TOWN OF MILFORD

Administrative Review

Subject: **Case #2021-26:** John and Alexandra Baer, 115 Federal Hill Road, Milford Tax Map 48, Lot 20-1
Special Exception Application, Accessory Dwelling Unit

SHEET TITLE:
Floor plans - ground

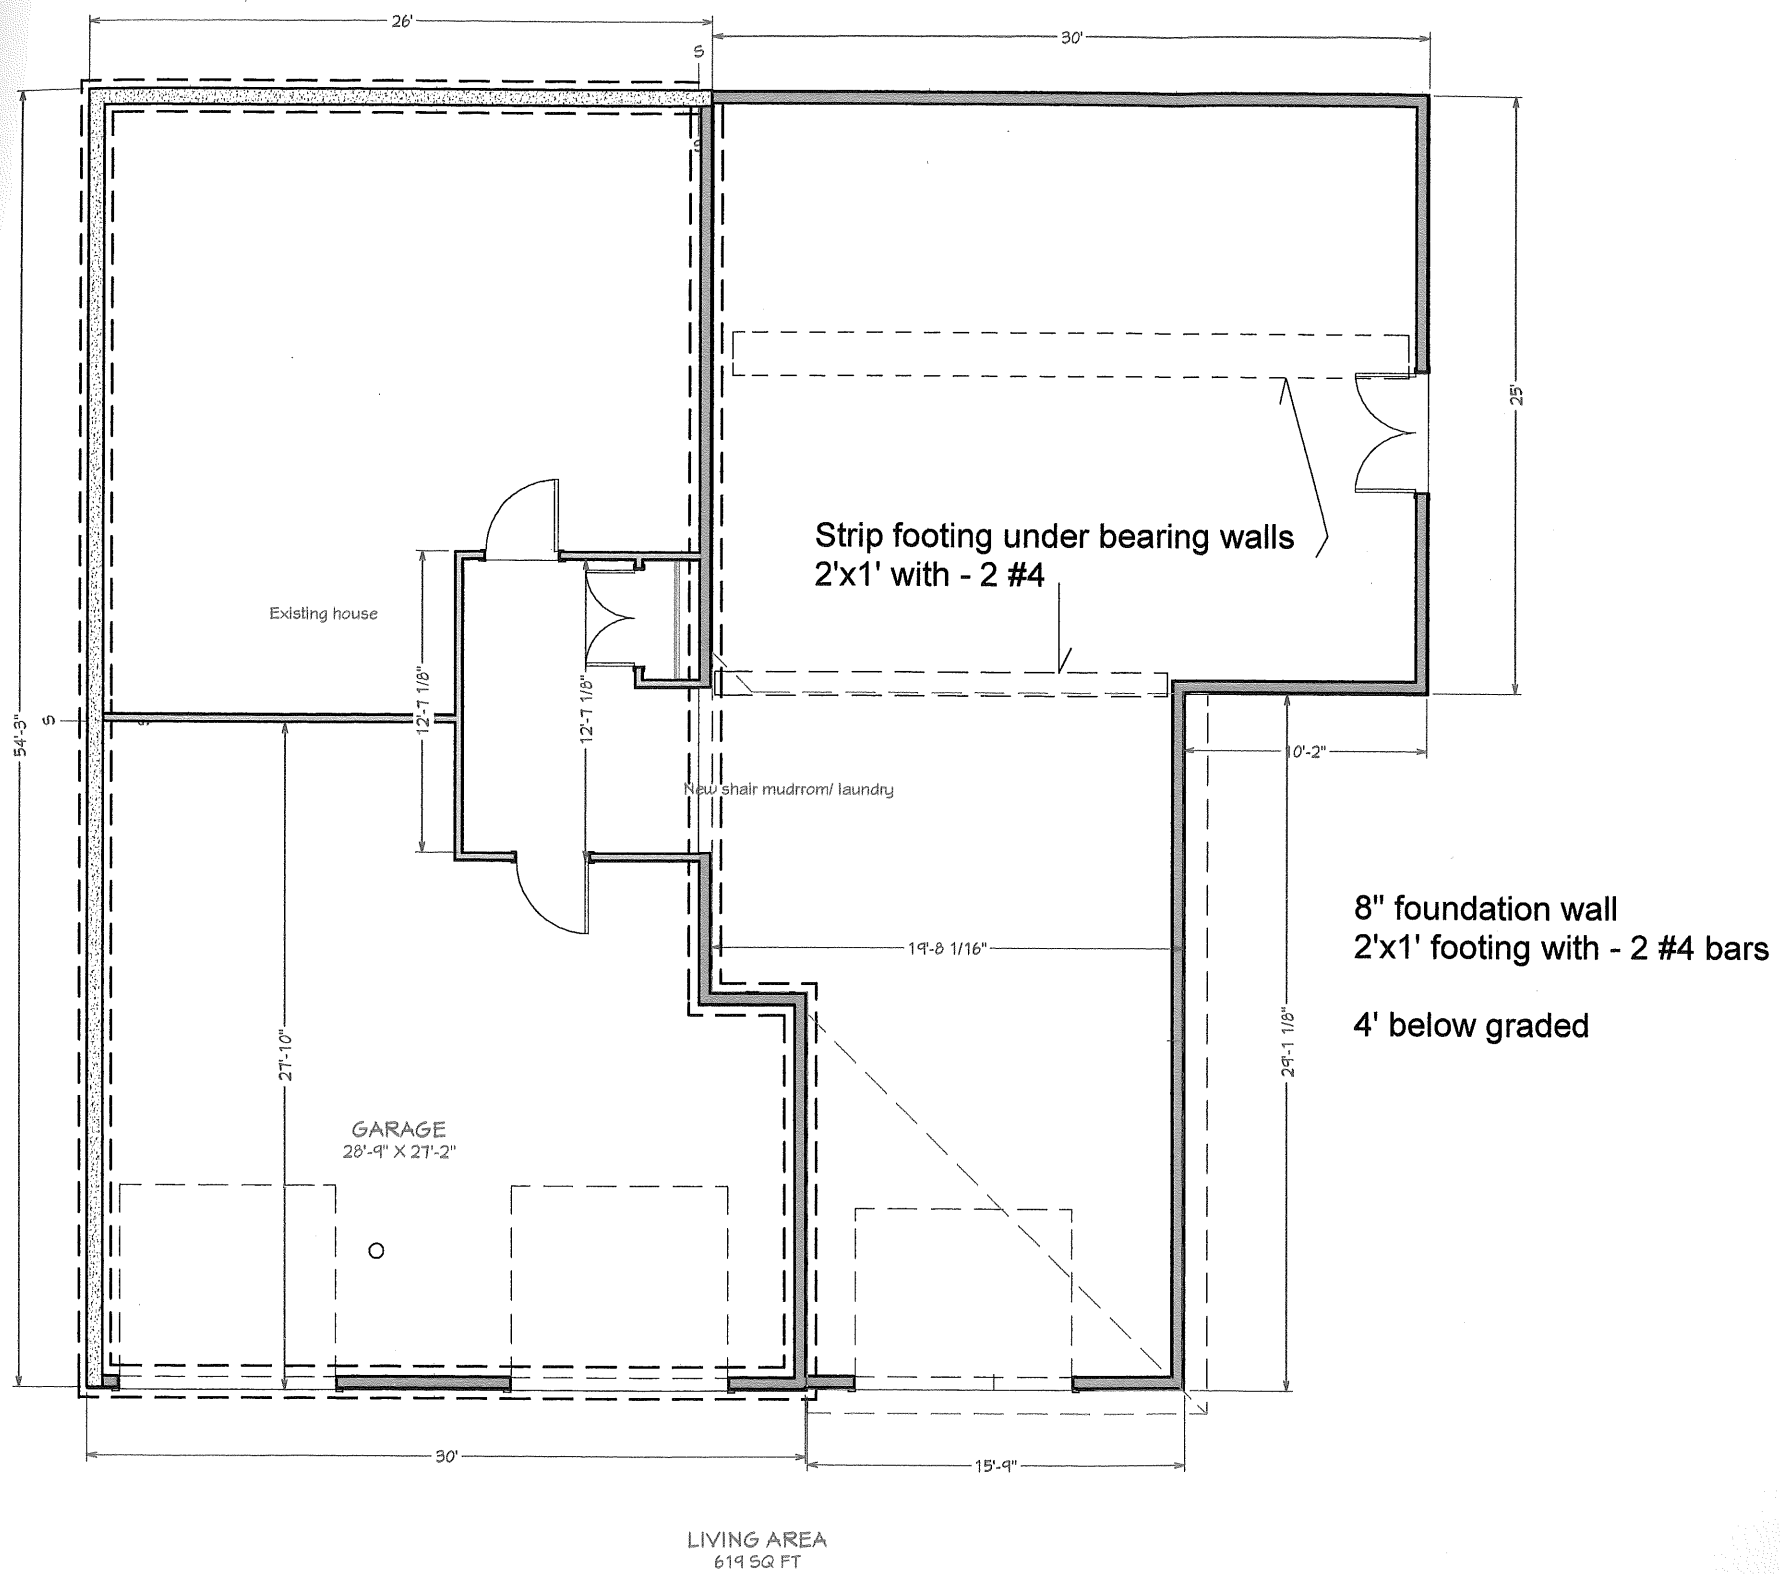
2. The proposal calls for construction of a new building addition containing a 750 square foot ground level one bedroom ADU. Access to the ADU will be through the proposed one bay garage and shared mudroom/laundry area. A separate exterior access has also been proposed for the ADU along the side of the residence.

- b. The proposed architectural plans are consistent with the existing residence and will not impact the character of the neighborhood. In addition, the proposed layout, access, and egress meet the minimum requirements of the ordinance.
